Final Report - Corrections Required
Application No. PL8719

PLAT OF KING'S LANDING UNIT 11

A 38.072 ACRE TRACT OF LAND, MORE OR LESS, A PORTION OF A 293.041 ACRE TRACT, DDC. NO. 2019035726, D.R. AND A PORTION OF A 130.570 ACRE TRACT, DDC. NO. 2019051482, O.R., SAID 38.072 ACRE TRACT BEING A PORTION OF SURVEY 137, ABSTRACT 579 AND SURVEY 139, ABSTRACT 577, SAID SURVEYS NAMED CUADRILLA IRRIGATION COMPANY, NUECES CO., TX

DATE PLOTTED: 6/19/25
CMP. NO. PLAT-SHT2
JOB NO. 24008
SCALE: 1" = 60'
PLAT SCALE: SAME
SHEET 2 OF 3

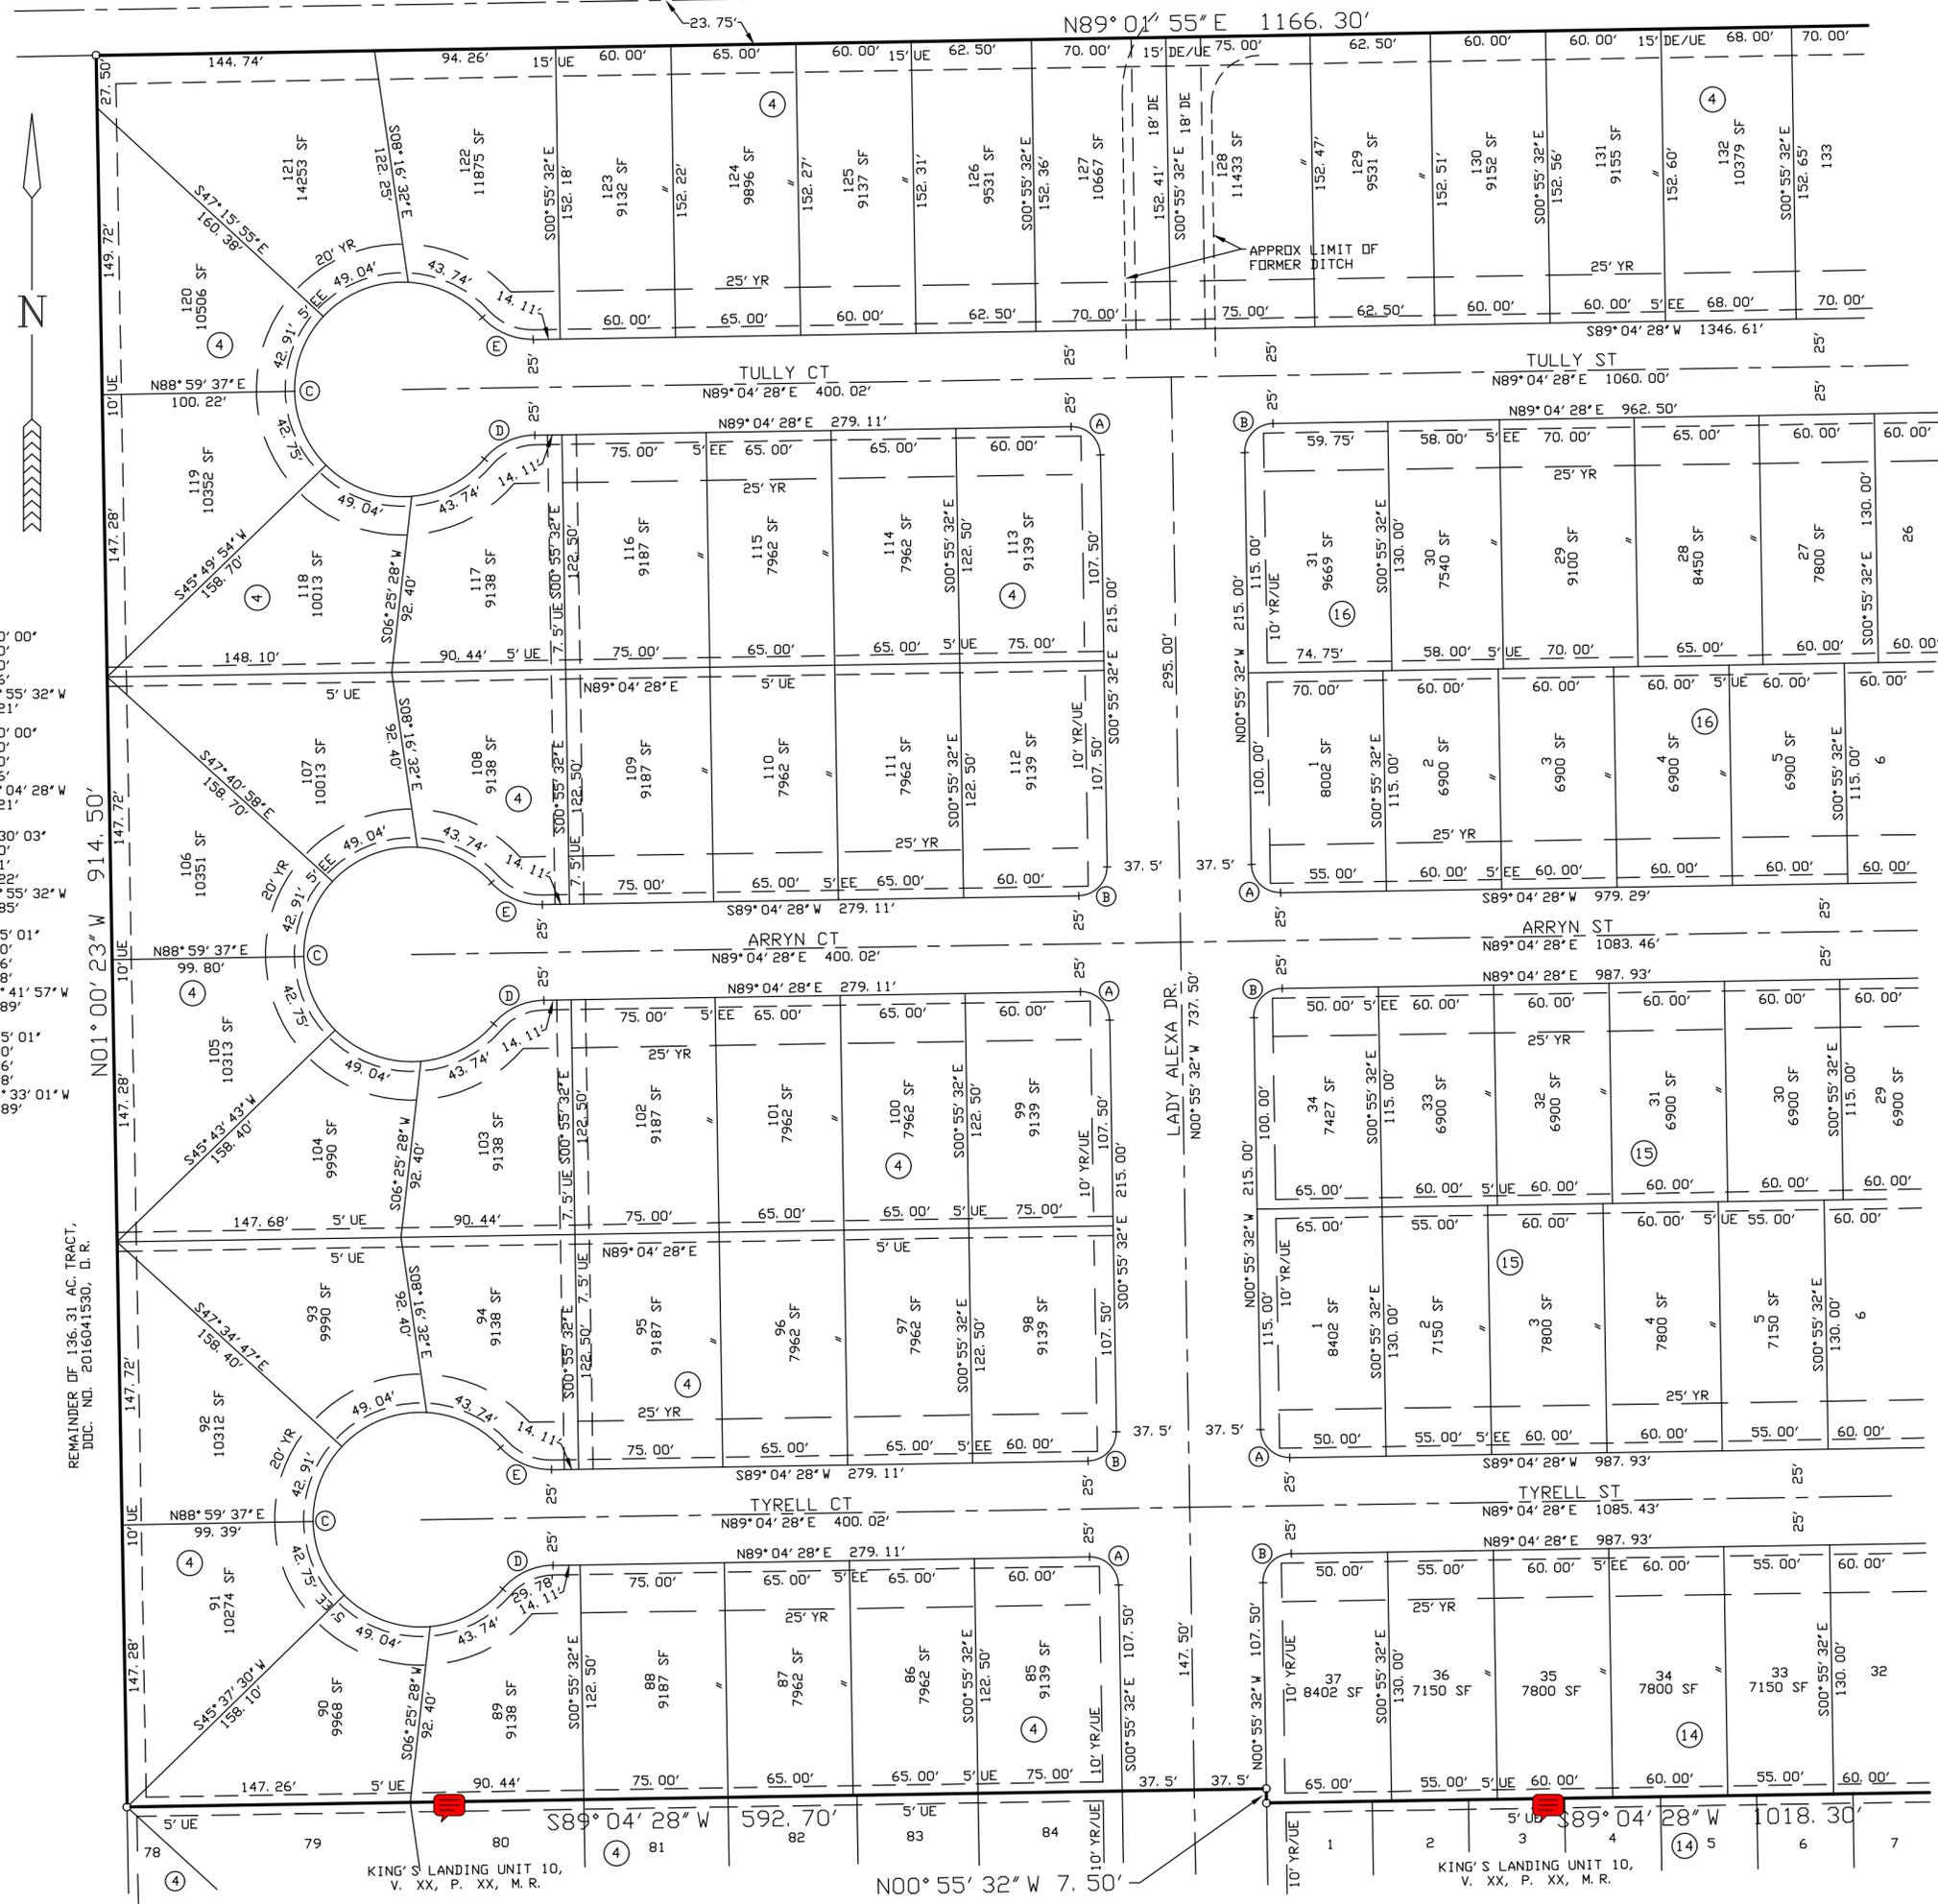
29	P001	Note	Mark Zans : LD	Closed	<p>Fire comments: 16--17</p> <p>16 Plat 503.2.5 Dead ends. Dead-end fire apparatus access roads more than 150 feet in length shall be provided with an approved area for turning around fire apparatus.</p> <p>17 Plat Table D103.4 Requirements for Dead-end fire apparatus access roads. Turnaround provisions shall be provided with a 96-foot diameter cul-de-sac.</p>
34	P001	Note	Mark Zans : LD	Closed	<p>Park Fee: 155 lots x 462.50 = \$71,687.50</p>
35	P001	Note	Mark Zans : LD	Closed	<p>Stormwater comments:</p> <p>Please review IDM Ch. 3.05: No Adverse Impacts. For new developments and other improvements that will increase the impervious cover, decrease the time of concentration (Tc), or increase peak flows from drainage areas, mitigation of adverse storm water impacts shall be required. Mitigation methods shall be designed to release the post-development storm water runoff from a site at a controlled rate, which does not exceed the predeveloped peak runoff rate. Habitable structures must be mitigated to the 100 yr-storm event, per UDC 8.2.8.</p> <p>If local private on-site storm water detention facilities are provided, they shall be designed using the appropriate methodology for their acreage and require a licensed professional engineer to inspect and certify that the facility is functioning as originally designed.</p> <p>Per City of Corpus Christi - Code of Ordinances Ch. 14, Art.X, Sec. 14-1003, a Storm Water Quality Management Plan (SWQMP) is required. The following information is not included with the submittal:</p> <ul style="list-style-type: none"> -Hydraulic calculations based upon established procedures (such as the rational method). This should be done for the predeveloped land and post developed land. -An on-site drainage plan, which details the direction of flow (using arrows or contours) and collection structures, including the size and required capacity of the drainage structures. -The on-site drainage plan should address how run-on storm water will be handled, including sheet flow entering the site from adjoining property.

Comment ID	Page Reference	Annotation Type	Author : Department	Status	Review Comments
					<ul style="list-style-type: none"> •PW STR: Informational - A person shall be held responsible for damage to and in public right-of-way for the criteria outlined in Sec. 49-39-9 in the City's Municipal Code and will be held responsible for restoring the City assets per Municipal Code Sec. 49-47-1, Sec. 49-54-6 and Sec. 49-49-3. For further information, please email ROWManagement@cctexas.com. •PW STR: Informational - Please refer to City of Corpus Christi Standards and Specifications for proposing roadwork, curb and gutter, sidewalk, utilities, etc and have the standards included in the plan set and the specifications referenced. Wherever available, please include a table of contents for which standards and specifications were used.
15	P002	Note	Mark Zans : LD	Closed	Provide Vol. and Pg number for Unit 10 recording.

16	P002	Note	Mark Zans : LD	Closed	Provide Vol. and Pg number for Unit 10 recording.
17	P003	Note	Mark Zans : LD	Closed	PW Streets comments: <ul style="list-style-type: none"> •PW STR: Were our PIP comments for this unit addressed? If so, can we see the developer's answers? •PW STR: Please provide an overall location map that identifies all units within King's Landing •PW STR: Informational - RCC pavement section shall adhere to Section 2 of the Pilot Program for Roller Compacted Concrete Roadway Improvements and Participation Agreement for Kings Landing Subdivision •PW STR: Informational - County Road 26 is on the Transportation Plan as a C3 Collector. Please coordinate with Public Works Traffic Department for a proposal to modify the Urban Transportation Plan. •PW STR: Informational - A person shall be held responsible for damage to and in public right-of-way for the criteria outlined in Sec. 49-39-9 in the City's Municipal Code and will be held responsible for restoring the City assets per Municipal Code Sec. 49-47-1, Sec. 49-54-6 and Sec. 49-49-3. For further information, please email ROWManagement@cctexas.com. •PW STR: Informational - Please refer to City of Corpus Christi Standards and Specifications for proposing roadwork, curb and gutter, sidewalk, utilities, etc and have the standards included in the plan set and the specifications referenced. Wherever available, please include a table of contents for which standards and specifications were used.
